Pentium® Processor Specification Update

Release Date: November, 1996

Order Number 242480-023

The Pentium processor may contain design defects or errors known as errata. Characterized errata that may cause the Pentium processor's behavior to deviate from published specifications are documented in this specification update.

21. Power-Up BIST Failure

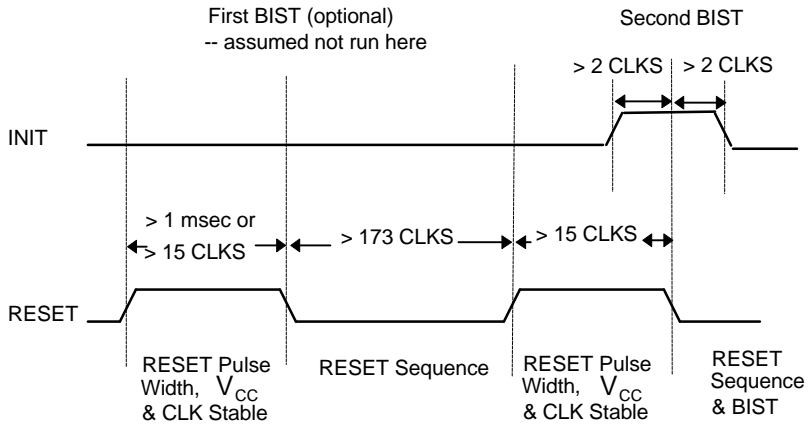
PROBLEM: The BIST (Built In Self Test) feature may fail.

IMPLICATION: Upon completion of BIST, a false failure may be reported. That is, a non-zero value may be returned in the EAX register, even though the part is operating correctly. As such, this erratum has no other product or system implications and is fully functional. To date, all observed false failures have returned a value of 20000H in EAX.

1. Invoke a double RESET — All false BIST failures have occurred during cold RESET. In order to accurately execute BIST, a double RESET sequence may be performed as shown in the figure below:

2. Use RUNBIST — BIST may be run through the RUNBIST instruction, available through the Test Access Port as documented. In this fashion, BIST will return correct values.

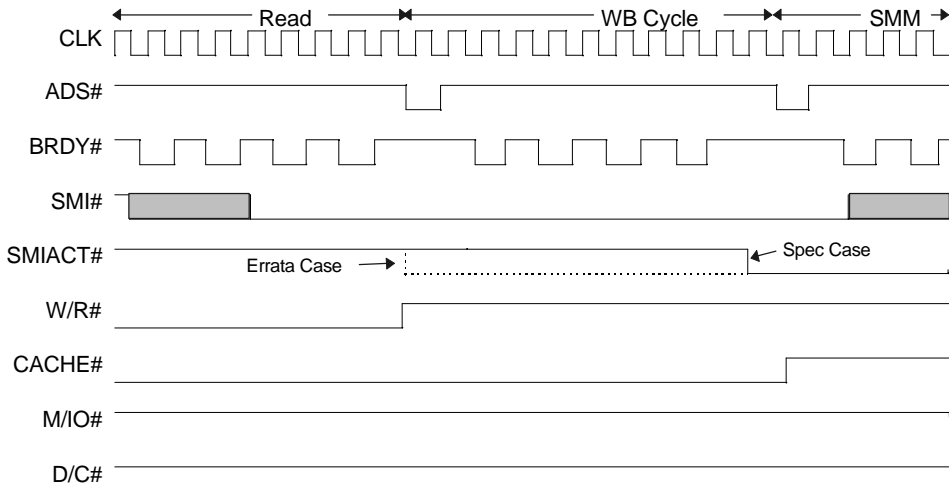
PROBLEM: Under rare circumstances, a BOFF# asserted to the processor, while it is internally waiting (looping) for the completion of all pending bus cycles, may cause the processor to proceed with the event before all pending bus activity is completed. However, bus cycle ordering will not change.

<i>Stop Grant special cycle</i>	If BOFF# is used to back off a Stop Grant special cycle, the processor may hang. Stop Grant and Stop Clock states for low power consumption cannot be used.
<i>AutoHALT special cycle</i>	If BOFF# is used to back off a AutoHALT special cycle, the processor may hang. This means that the lower power AutoHALT state is not usable. This does not affect the normal HALT state, entered with the HLT instruction though.
<i>INIT asserted while there is a memory mapped APIC register access</i>	If BOFF# is used to back off a memory mapped APIC register access (read or write) while an INIT is pending, the processor may hang. The INIT would only be used during a switch from Protected to Real mode, which is normally associated with a system reboot. In the processor lockup occurs a reboot may have to be performed via system powerdown.

WORKAROUND: Restrict the use of BOFF# for the described events. In addition, the SMI# pending event can be eliminated by locating SMRAM so that it does not shadow standard memory and does not require SMIACK# for memory decode. The OUT or Serializing instruction events are also eliminated if the next instruction does not depend on the result of the event before executing the instruction. The Stop Grant special cycle event is also eliminated by not asserting STPCLK#. The AutoHALT special cycle event is also eliminated by disabling AUTOHALT (set TR12.AHD bit to '1').

11. ***Future Pentium® OverDrive® Processor FERR# Contention in Two-Socket Systems***

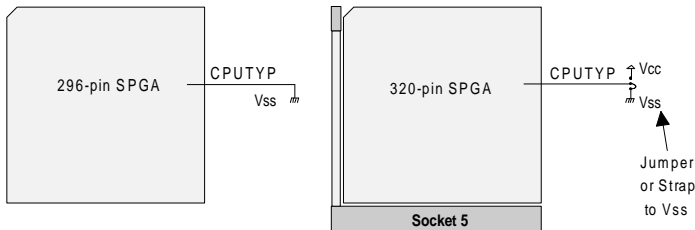
PROBLEM: When the future Pentium OverDrive® processor is plugged into Socket 5 of a two socket 75-, 90-, or 100-MHz Pentium processor system, the OEM processor shuts down following RESET to allow the OverDrive processor to drive the bus. In this case, the FERR# output of the 75-, 90-, and 100-MHz Pentium processor continues to be driven HIGH (inactive).

1. **For upgradability in two socket systems:** External logic may be used to connect the FERR# outputs from the two sockets (296-pin SPGA and 320-pin Socket 5) in a way that will resolve the signal contention.
An external AND gate may be used to combine the outputs of the FERR# signals from the two sockets. A pullup resistor ($\geq 3K\Omega$) is required on the FERR# output from both of the sockets in order to allow proper operation of both the dual processor and the future Pentium OverDrive processor. See the following figure:

2. **Upgradability by modifying a two socket system to be a single socket system:** This workaround involves modifying a design that includes two socket sites (296-pin SPGA and 320-pin Socket 5) such that it effectively becomes a single socket design.

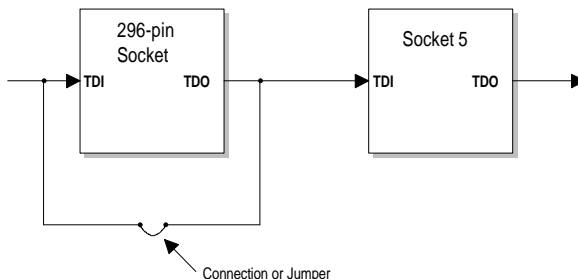
A dual processing two socket system must have CPUTYP tied to V_{SS} on the 296-pin SPGA OEM socket, and tied to V_{CC} on Socket 5 (320-pin SPGA). This workaround includes inserting a jumper on the Socket 5 CPUTYP signal (or strapping Socket 5 CPUTYP directly to V_{SS}) to make this the primary processor site. The system would then effectively become a single-socket design. NOTE: If a jumper is used, it must be set by the OEM prior to system sale (not by the end-user at the time of the future Pentium OverDrive processor purchase and installation). This jumper would set the CPUTYP signal on Socket 5 to V_{SS} . If the same board design is used for dual processing, this jumper (or strapping option) may be set to V_{CC} for those systems, as shown in the following figure:

Other implications of this workaround include Boundary Scan, and any other signals not connected together between Socket 5 and the 296-pin SPGA socket site.

If Socket 5 follows the 296-pin socket in the Boundary Scan chain, the TDI input and TDO output of the 296-pin socket site must be connected together by the OEM prior to system sale in order to skip this socket site and complete the path to socket, as shown in the following figure. This connection is necessary only if Boundary Scan will be used by end-users after system sale.

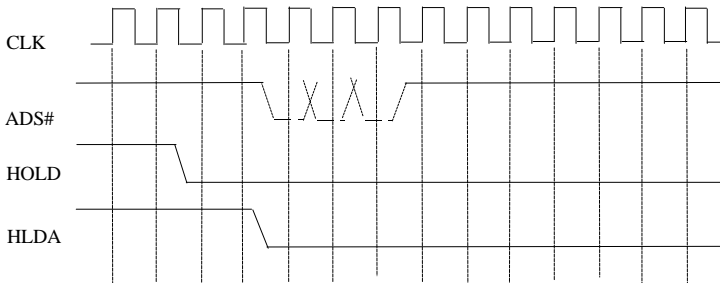
PROBLEM: The *Pentium Processor Family Developer's Manual*, Volume 1 states that the TAP Hi-Z state can be terminated by resetting the TAP with the TRST# pin, by issuing another TAP instruction, or by entering the Test_Logic_Reset state. However, the indication that the processor has entered the TAP Hi-Z state is maintained until the next RESET. Therefore by using the above methods alone, the TAP Hi-Z state can not be terminated.

IMPLICATION: When the TAP Hi-Z instruction is enabled and executed, using the methods described in the *Pentium Processor Family Developer's Manual*, Volume 1 may not terminate the Hi-Z state.

WORKAROUND: To exit TAP Hi-Z state, in addition to the methods described above, the processor needs to be RESET as well.

Pending Cycle May Be Delayed

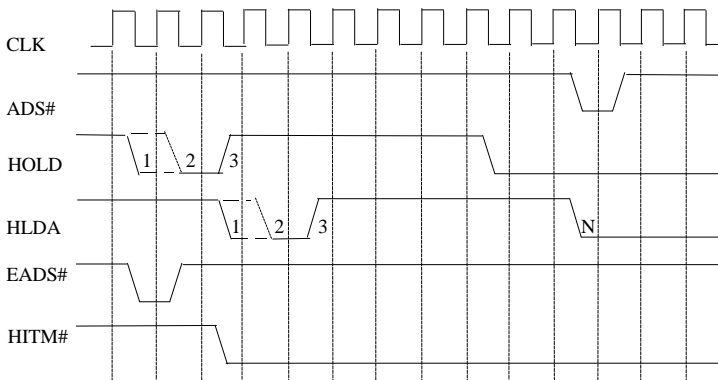
In two cases, for example, if HOLD is deasserted for one clock (i.e., clock 2) or two clocks (i.e., clocks 1 & 2) and then reasserted, the window may not be large enough to start a pending snoop writeback cycle. The writeback cycle may be delayed until the HLDA is deasserted again (i.e., clock N). See diagram below.

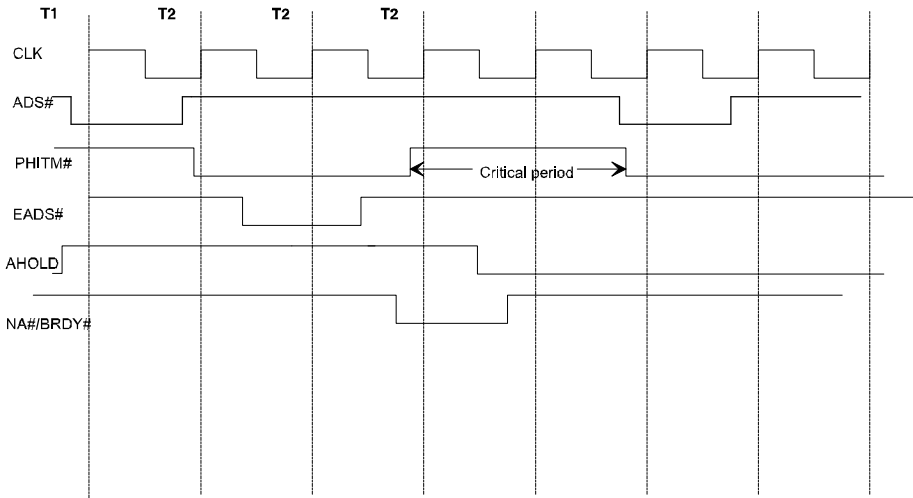
IMPLICATION: This problem occurs only in dual processor systems and will cause one of the processors to hang.

1. Do not assert STPCLK#.
2. Ensure that BRDY# is asserted within 4 CLKs after the Stop Grant bus cycle has begun.

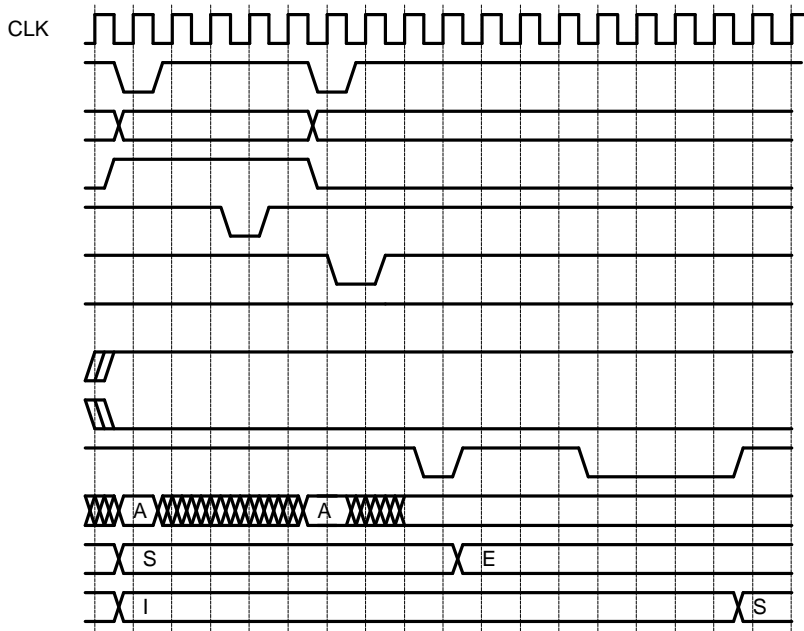
PROBLEM: This is a dual processor erratum: There is a very short setup and hold time for the address bus lines in Dual Processing mode to support the single clock interprocessor snoop response required for cache coherency. In this case the 3ns setup specification is enough for the address to propagate to the cache but it does not allow enough time for the address to propagate to the parity calculation circuits. There is a chance that the APCHK# line will spuriously go active showing a parity error on the address bus.

IMPLICATION: Internal measurements of these address signals show that if the 3ns spec is met, the addresses will be latched correctly. Since the parity portion of the circuitry does not meet this timing there is no way to guarantee the APCHK# output is valid. Systems using the APCHK# pin will perform the APCHK# interrupt error routines.

WORKAROUND: Designs based on the 82430NX PCIset and other chip sets which ignore APCHK# in a dual processor environment are therefore not affected. If the address setup (t_{83}) and Maximum Valid Delay (t_6) timings in the *Pentium Processor Family Developer's Manual*, Volume 1, Section 23.4.5.2 and 23.4.5.3 are followed, this erratum will not apply to C-step components and future steppings.

CASE 1:

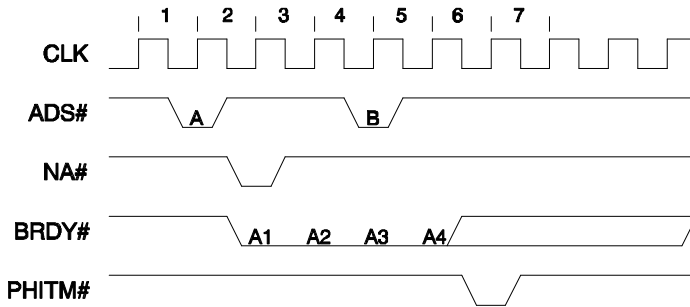
For this erratum to occur, either of two specific sequence of conditions must occur on the bus as shown in the figures below:

- The processor issues read cycle A which may be pipelined into an earlier (not shown) cycle.
- Cycle A will be completed by the system as a 2-1-1-1 (zero wait state) cycle.
- One clock after issuance of the ADS#, NA# is asserted by the system.
- A pipelined cycle (B) is asserted by the MRM in clock 4.
- Cycle A completes on the bus in clock 5.
- One clock later, PHITM# is issued by the LRM.

CASE 2:

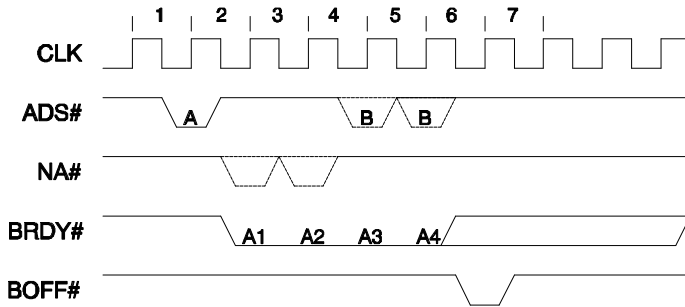
- The processor issues read cycle A which may be pipelined into an earlier (not shown) cycle.
- Cycle A will be completed by the system as a 2-1-1-1 (zero wait state) cycle.
- One or two clocks after issuance of the ADS#, NA# is asserted by the system.
- A pipelined cycle (B) is asserted by the MRM in either clock 4 or clock 5.
- Cycle A completes on the bus in clock 5.
- One clock later, BOFF# is issued by the system.

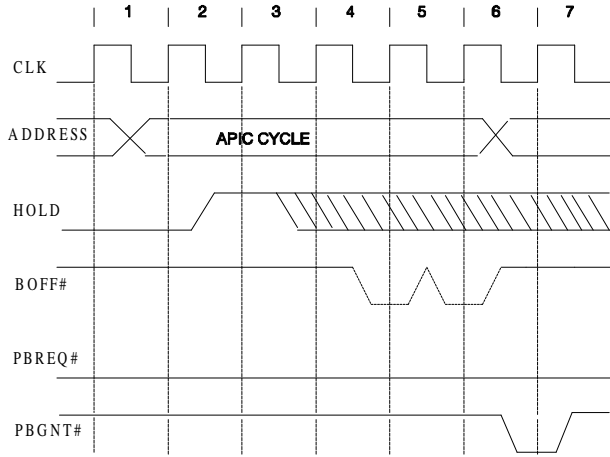
PROBLEM: This erratum only occurs in a dual processing environment. Extra invalidates may occur into the L1 cache due to assertions of EADS#. If EADS# is asserted while the processor is driving the bus, an invalidate into the processor's L1 cache may occur.

IMPLICATION: The specification states that EADS# is ignored while the processor is driving the bus. Occurrence of this erratum means that unnecessary invalidations and writeback cycles may be performed resulting in sub-optimal performance.

WORKAROUND: The system should not assert EADS# while the CPU owns the bus. Designs based on the 82430NX PCIset and other chip sets which do not assert EADS# while the CPU owns the bus are therefore not affected.

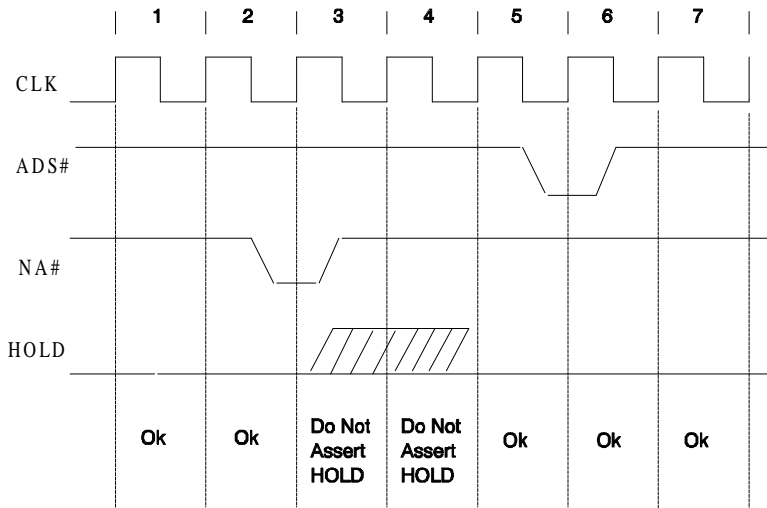
IMPLICATION: This problem affects dual processing (with CPU local APIC enabled) that assert HOLD and BOFF#. When the problem occurs, the dual processing arbitration machines of both processors get out of synchronization causing both processors to park on the bus. This will result in a system hang.

1. Do not use HOLD/HLDA protocol together with BOFF#. Use one or the other. Designs based on the 82430NX PCIs set and other chip sets which do not use the HOLD/HLDA protocol together with BOFF# are therefore not affected.
2. In a non-pipelined system, avoid assertion of HOLD when the bus is idle. Asserting HOLD while CPU is running a bus cycle (between ADS# and last BRDY#) will ensure that HOLD does not hit an APIC cycle. Alternatively, if HOLD is asserted when the bus is idle, avoid asserting BOFF# two or three clocks after HOLD is asserted (as shown in figure above.)
3. In a pipelined system, use the same workaround as described in #2 with an additional requirement. Since an APIC cycle can be pipelined into another bus cycle, avoid assertion of HOLD in the clocks between NA# and the next ADS# (as shown in figure below.)

13DP. System Hang After Hold During Local APIC 2nd INTA Cycle

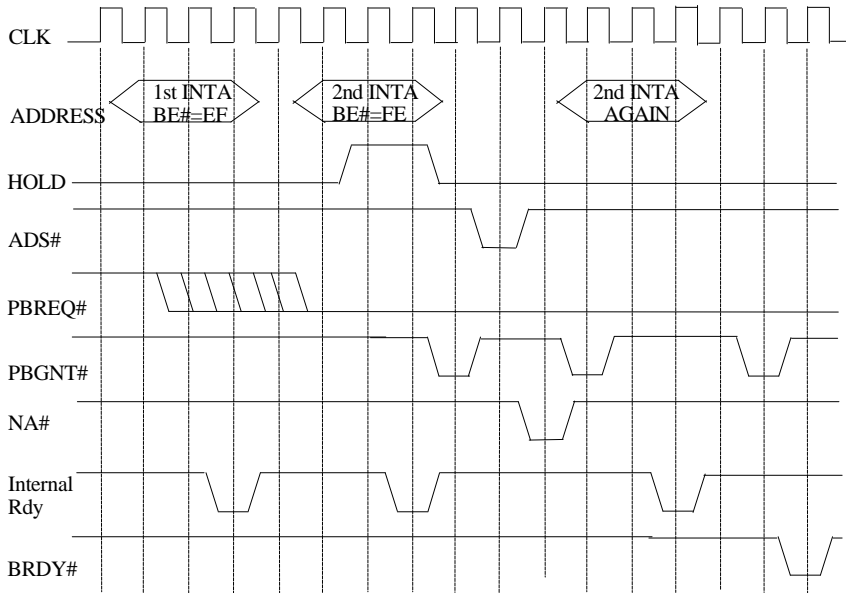
PROBLEM: In a dual processor system, the following sequence of events may cause the system to lock up:

1. One of the CPU's (i.e. CPU A) initiates the first and second internal APIC INTA cycles. The INTA cycles are not driven on the external bus. CPU B requests ownership of the bus by asserting PBREQ#.
2. HOLD is asserted during the 2nd INTA cycle and PBGNT# is asserted.
3. CPU B issues a read or write cycle and receives NA# before completion of the cycle. The bus is granted back to CPU A.
4. CPU A reissues the second INTA cycle and grants the bus to CPU B.
5. CPU A hangs because the internal Rdy# and BRDY# were recognized out of order.

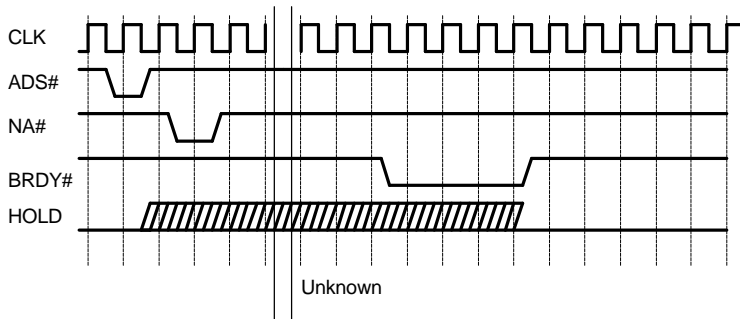
PROBLEM: If the processor is reading one of its local APIC registers when the HOLD pin is asserted, PCHK# may be asserted for one clock even though there is no data parity error. PCHK# will be asserted if the values of the data bits [D31:0] and the parity bits [DP3:DP0] do not match during the HOLD/HLDA transaction.

WORKAROUND: If data parity checking and the local APIC are both enabled, deassert PEN# (parity enable) during the time that HOLD is active. This signals to the processor that parity is not being driven from the system and PCHK# will never be driven in response to this data transfer.

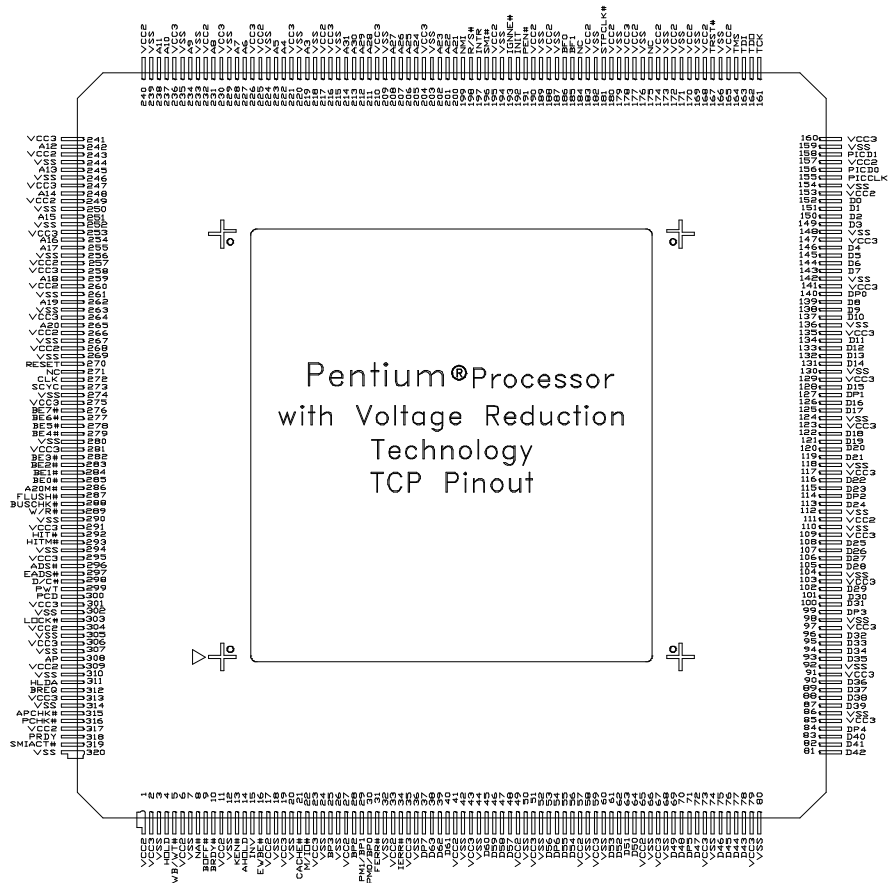
The TCP pinout drawing on page 8 of the Pentium Processor with Voltage Reduction Technology Data Sheet was inadvertently rotated. The correct orientation is shown below.
